Response to ACER's consultation

ESC GC
29 September 2023

RfG - Challenges of maintaining a separate definition of ESM

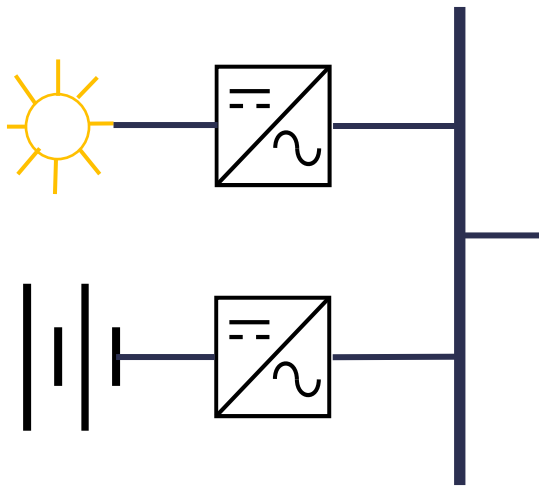
The installation on the left is one PPM (Recital 9 RfG 1.0 and as per the EG Storage's report).
It is two separate PPMs in ACER's RfG 2.0 proposals (Recital 9 RfG 2.0).

The installation on the right under the current RfG approach is a single 1.5MW PPM.

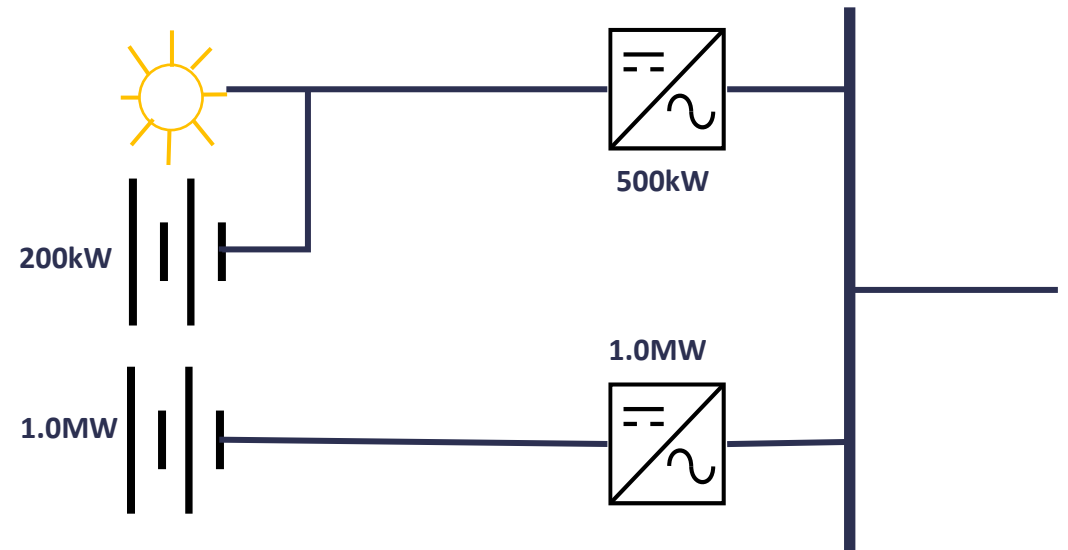
In ACER's proposal RfG 2.0, the battery is an ESM, but what is the combination of solar and battery which are DC coupled?

Is it a PGM or is it an ESM? Because of the definitions from ACER it could be either, and if an ESM, one where import and export are asymmetric.

So the confusion does not seem fatal, but it works against aggregating the non-synchronous generation on the site.

Is it one 1.5MW Type B PPM, or a 500kW Type A PPM and a 1.0MW Type B PPM? (considering an A/B type threshold of 1MW)
